REV.
B

AS34671™

RATIONALE

CONNECTOR, PLUG, ELECTRIC,
CRIMP TYPE, PUSH-PULL COUPLING,
SERIES 3 (CLASS L AND E)

FIGURE 1 - CONNECTOR CONFIGURATIONS AND DIMENSIONS (CONNECTOR VIEW)

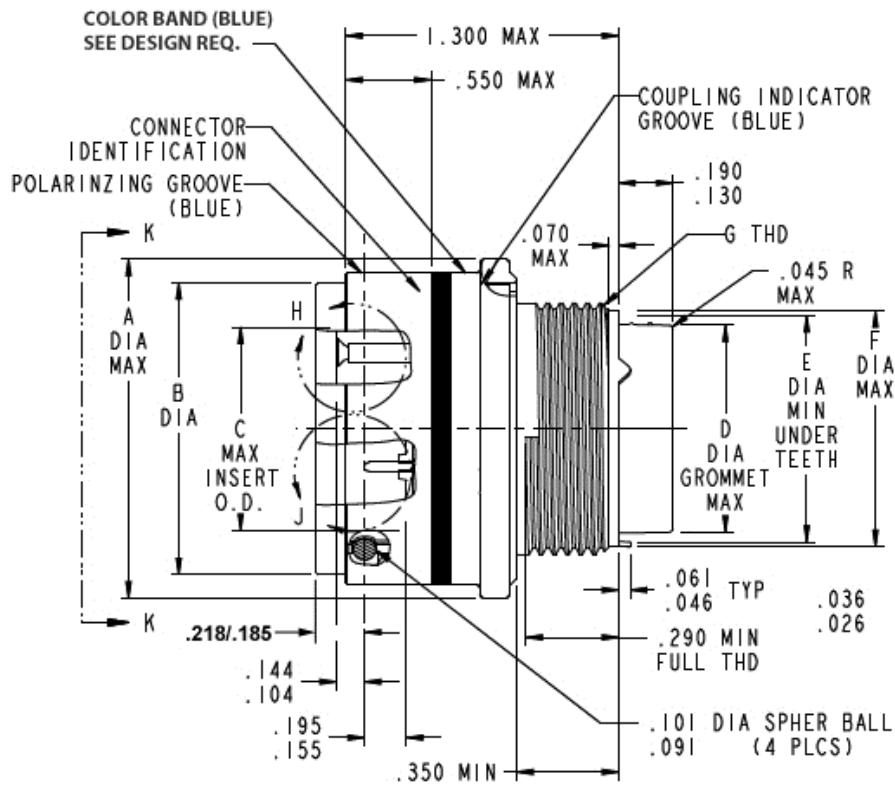
REVISION IS REQUIRED TO CORRECT THE FEATURE LINE FOR THE .218-.185 DIMENSION IN FIGURE 1, THE LEFT SIDE BOUNDARY LINE SHOULD BE THE END OF THE SHELL.
